Elf Mushroom Farm & Substrate Plant Project

*Part 3A Modification
Assessment
(08_0255 MOD 3)*

December 2019

Figure 4 | Overview of proposed modifications to the substrate plant site

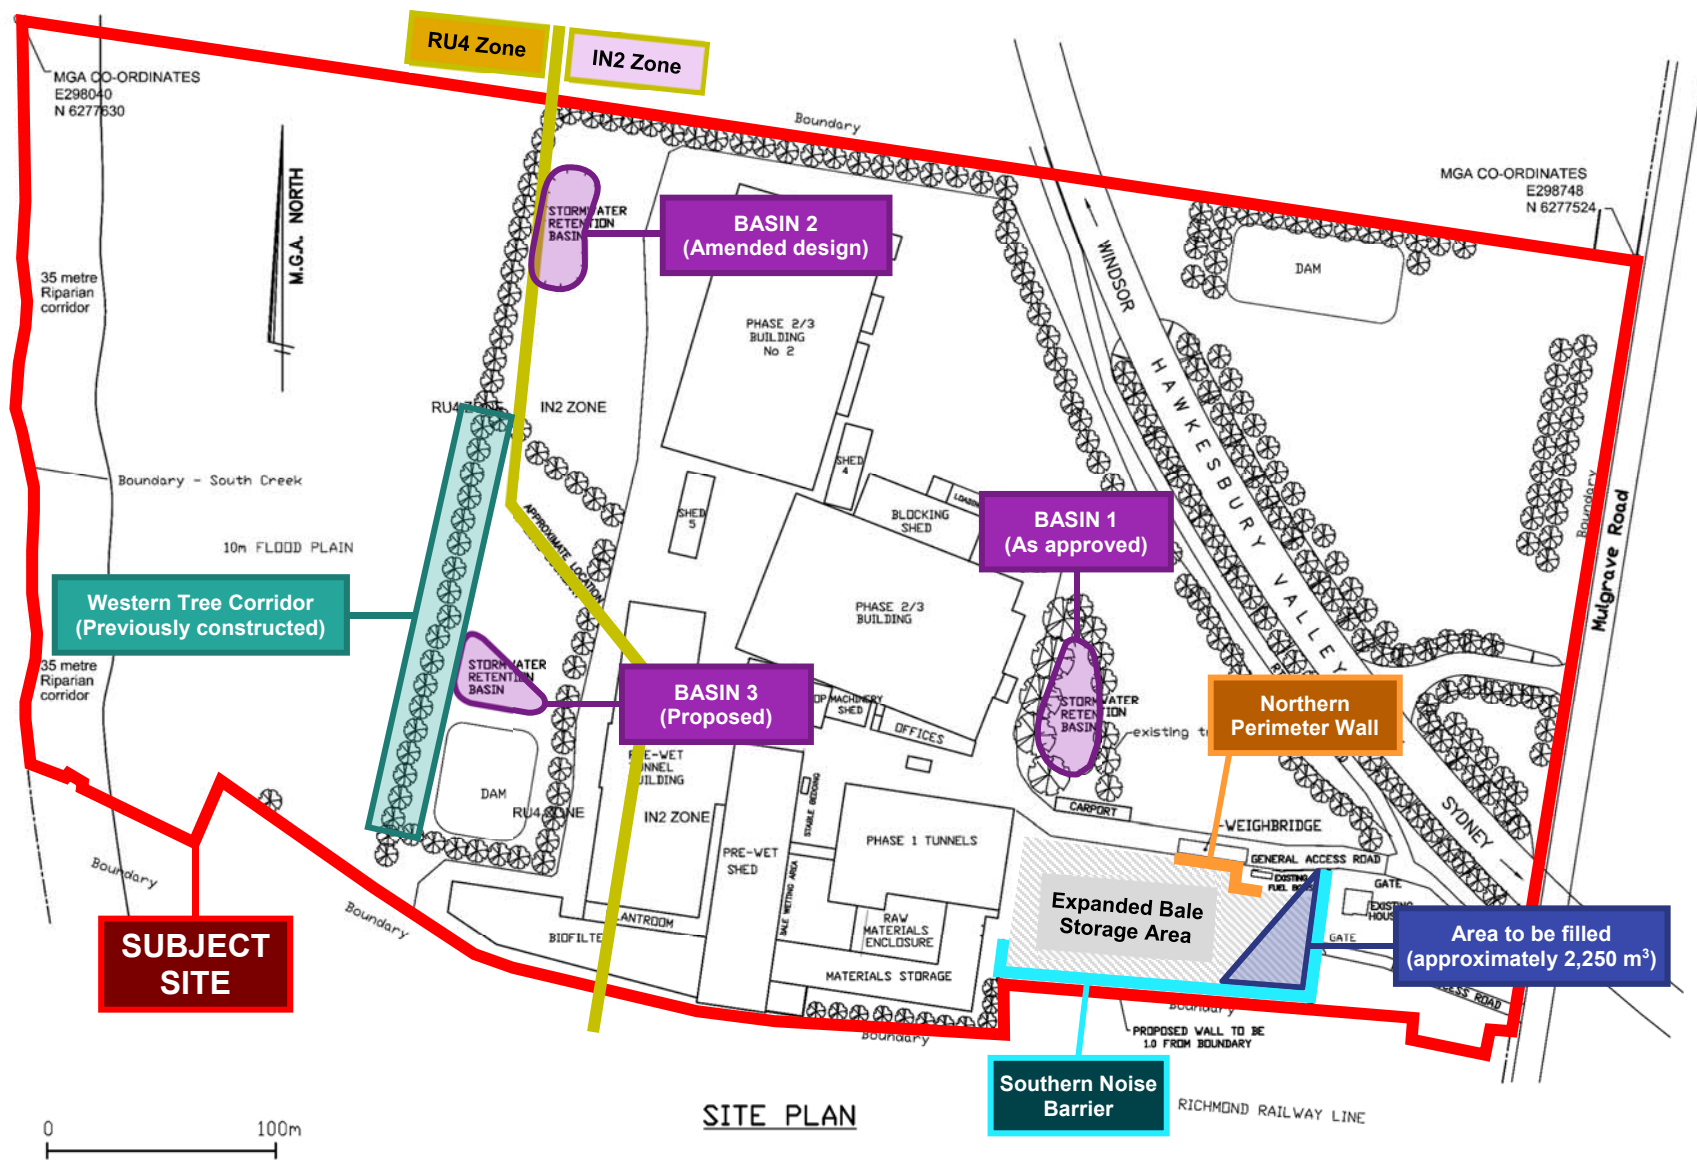
The expansion would require the importation of up to 2,250 m³ of fill to raise the south-western corner of the site to the finished floor level of the storage area (16 m AHD). Once complete, the expanded bale storage area would have a hardstand area of approximately 6,720 m² (see **Figure 4**).

The modification request also proposes the construction of a northern perimeter wall to separate the outdoor bale storage area from the adjacent weighbridge and fuel storage tank (see **Figure 4**). The perimeter wall would be approximately 50 m in length, and would be separated by a distance of 2 m to the weighbridge and 6 m to the fuel storage tank. For consistency, the wall would be of an identical height and design to the proposed southern noise barrier (see **Section 2.1.1** above).

In February 2015, the Proponent commenced construction of a mounded tree corridor located along the western boundary of the substrate plant site (see **Figure 4**). The corridor was designed to reduce the visibility of batters and structures approved under 08_0255 MOD 1, and to complement existing screening already established in the north-western section of the site. The Proponent is subsequently seeking approval for the western tree corridor as part of the subject modification request.

Figure 5 | Overview of proposed stormwater management system

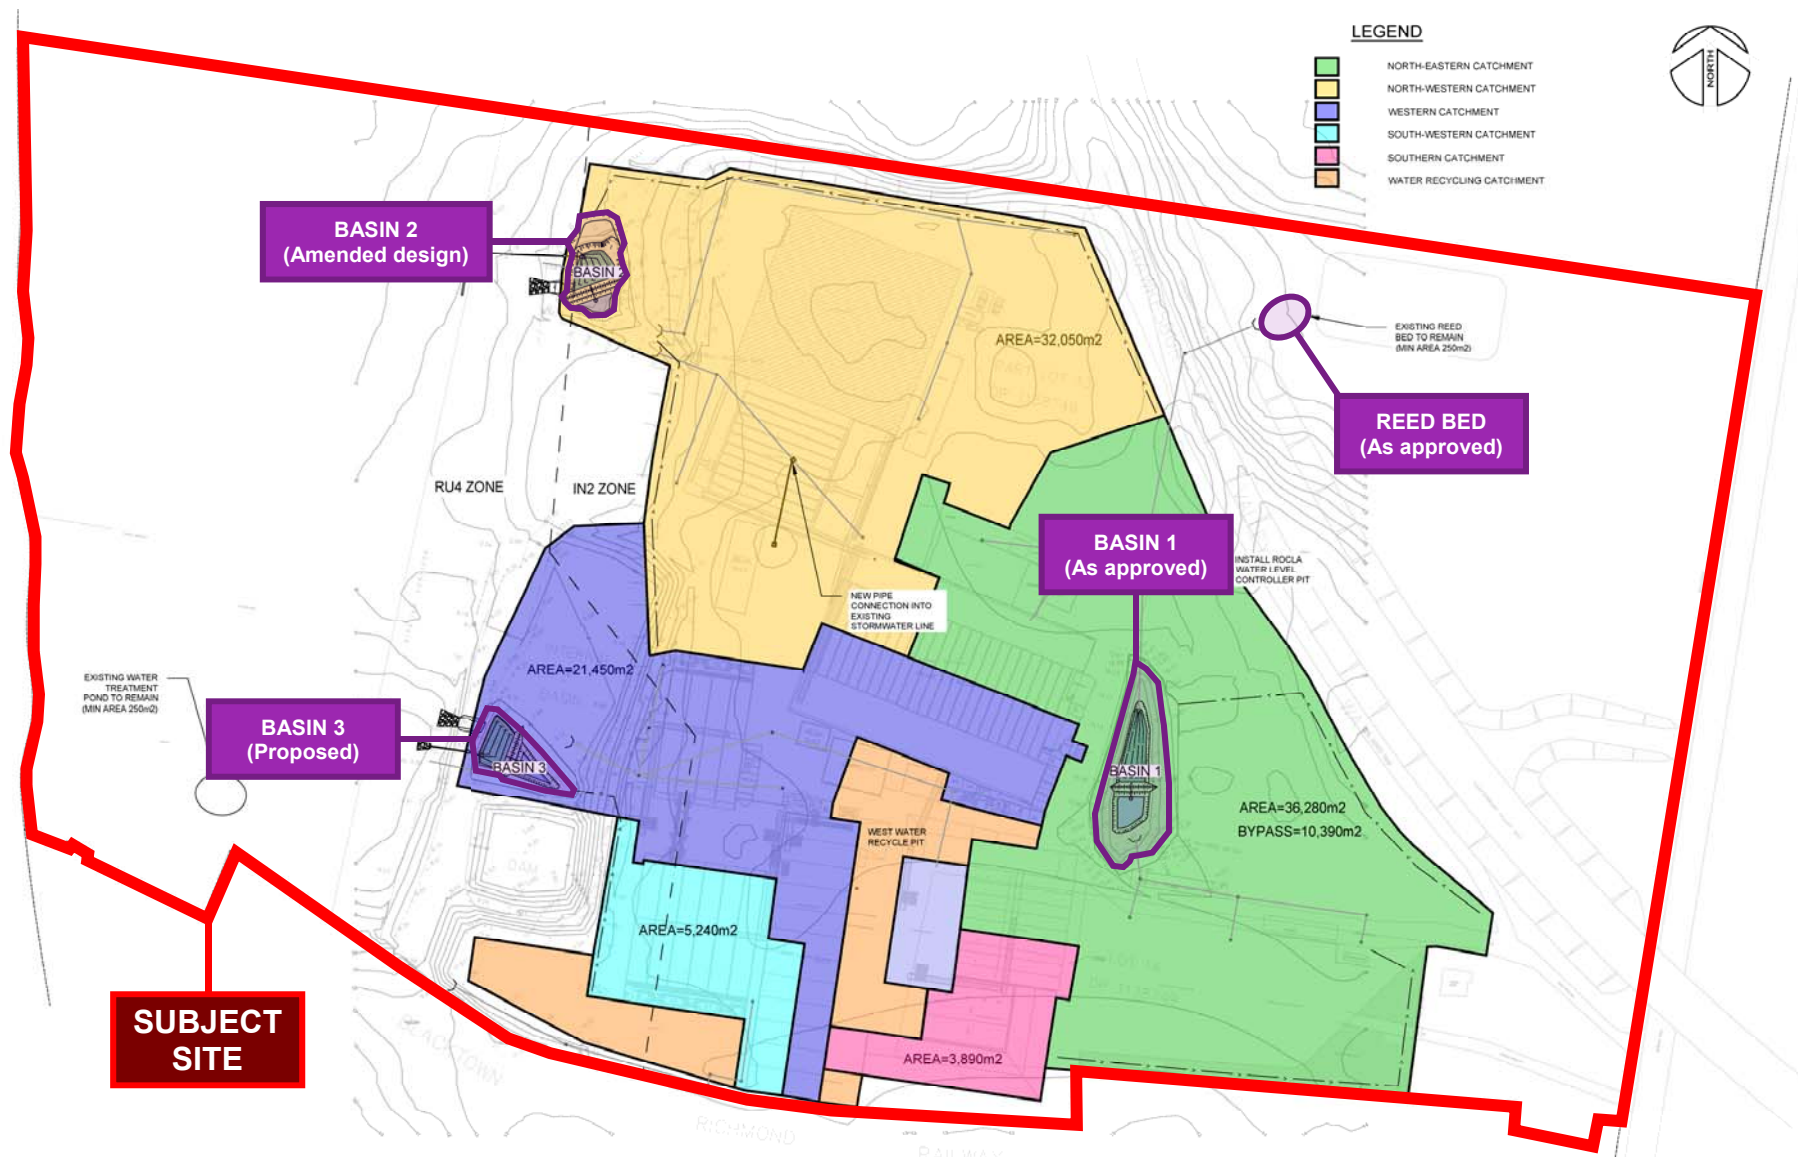
- reduce and reconfigure Basin 2, incorporating a bio filter, on-site detention basin and sedimentation basin into one structure
- construction of a new south-western basin (Basin 3), incorporating a discharge control pit, bio filter and sedimentation basin (see **Figure 5**).

<ul style="list-style-type: none"> In support of the amendments to the approved stormwater management system, the Proponent's EA included a Stormwater Management Report (SMR) for the substrate plant site. During the exhibition period, Council requested further information regarding the water quality control measures to be implemented, while the EPA recommended the Proponent incorporate stormwater isolation valves into the design of the stormwater management system. Following the completion of additional MUSIC modelling as part of its RTS, the Proponent undertook minor amendments to the design of the stormwater detention basins, including the provision of stormwater isolation valves into each basin in accordance with the EPA's requirements. The Proponent's RTS concluded the amended stormwater management system would achieve the stormwater quality targets established in Council's development control plan. Council and the EPA did not provide any further comments in relation to stormwater. The Department is satisfied the amended stormwater management system is appropriate on the basis that: <ul style="list-style-type: none"> the amended system would have sufficient stormwater detention capacity to cater for a 1 in 100-year storm event the amended system would ensure peak stormwater discharge rates do not exceed pre-project levels 	<p>Require the Proponent:</p> <ul style="list-style-type: none"> update the substrate plant's WMP to reflect the amended stormwater management system.

Assessment	Recommendation
<ul style="list-style-type: none"> o the updated MUSIC modelling shows pollutant loads from the site would achieve Council's stormwater quality targets. • The Department's assessment concludes the amended stormwater management system has been designed in accordance with the requirements of Council and is adequate for the management and treatment of flows from the site. • The Department has recommended the Proponent update the substrate plant's Water Management Plan (WMP) to reflect the amended stormwater management system.
